Product Change Notification

PCN-IFC-7877-2022

Description for Product Change Notification

Previous Product	New Product

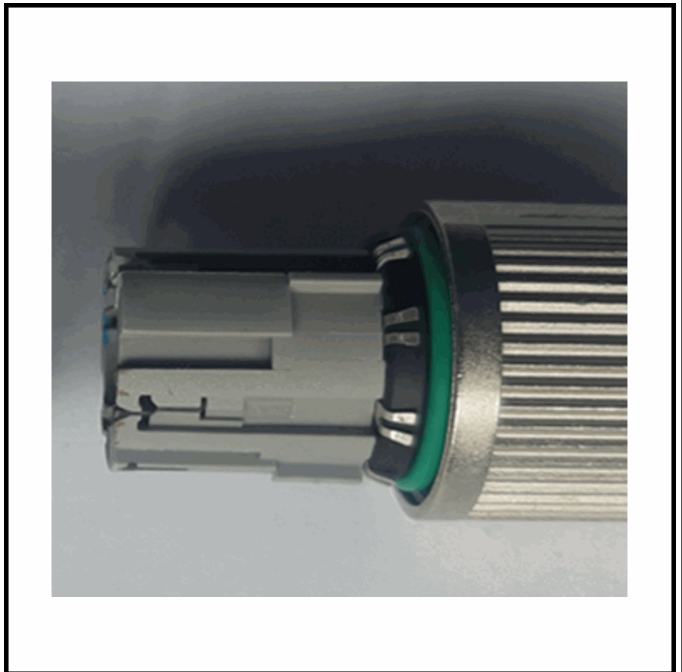
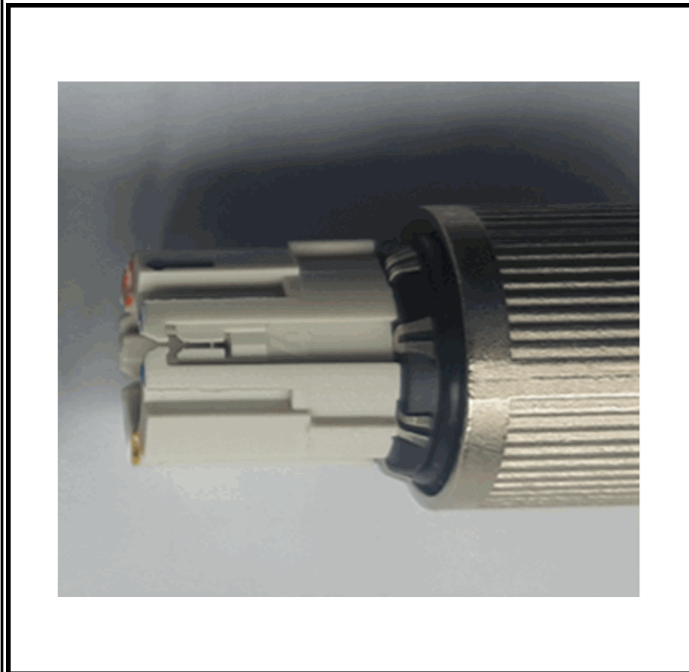
The SPEEDCON thread on the shielded M12 connectors with QUICKON connection has been changed to a full-thread M12. As part of this change, the surface of the M12 thread has been tin-plated. In addition, the cable seal has been changed from NBR to FKM and the maximum external cable diameter has been extended to 10 mm. The sealing ring on the cable ring has also been changed from NBR to FKM. It is green for better visibility. The possible connection area of the IDC terminal blocks is indicated on the housings. This is being adapted, as the possible connection area could be extended for some items. The properties of SPEEDCON are no longer possible. All other properties remain unchanged or will be extended.
